-
- 1.1 Amendment to Planning Permit Application No. PLN16/0434.01 - 26 - 56 Queens Parade, Fitzroy North - Construction of two or more dwellings on a lot in a 10-storey building plus two basements, use of part of the land for the sale and consumption of liquor (on premises), partial demolition, reduction of the car parking requirements and alterations of access to a road in Road Zone Category 1.**
-

Executive Summary

1. This report provides an assessment of the application to amend Planning Permit PLN16/0434 (the Permit) relating to land at 26 – 56 Queens Parade, Fitzroy North. The permit allows:

3. On 4 August 2020, Council received notice from VCAT of a request pursuant to section 87A of the Act to amend the Permit. The proposal generally seeks approval for:

Figure 59 Ground floor Plan

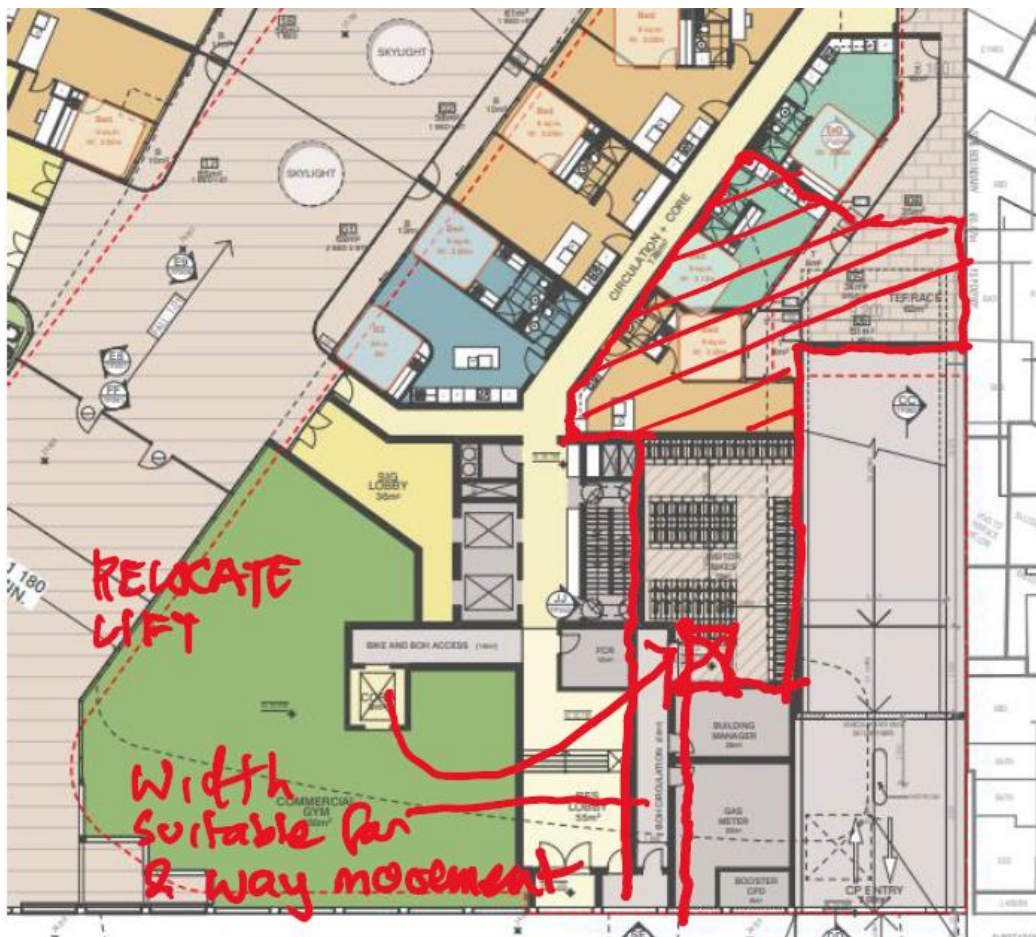
- 253. The proposal provides bicycle parking in excess of this requirement with a total of 393 spaces provided.
- 254. The proposal provides no information regarding provision of shower and change room facilities.
- 255. Pursuant to Clause 52.34-5 also requires shower and change room facilities be provided at a rate of 5 shower/change room for the first 5 employee bicycle spaces, and 1 shower/change room per 10 spaces thereafter. Little to no information has been provided regarding change rooms and or showers other than a comment that this could form a condition of permit.
- 256. Councils consultant urban designer has raised a number of concerns with the layout and location of the bike parking and the lack of shower and change room facilities, it is recommended the following concerns be addressed:

(a) *Provide direct access from the street without steps to bicycle storage and lifts (not via a lobby and stairs as currently proposed);*

(b) Expand ground level bicycle storage and relocate a substantial amount of basement level 2 bicycle storage to ground level and basement 2 level storage to basement level 1;
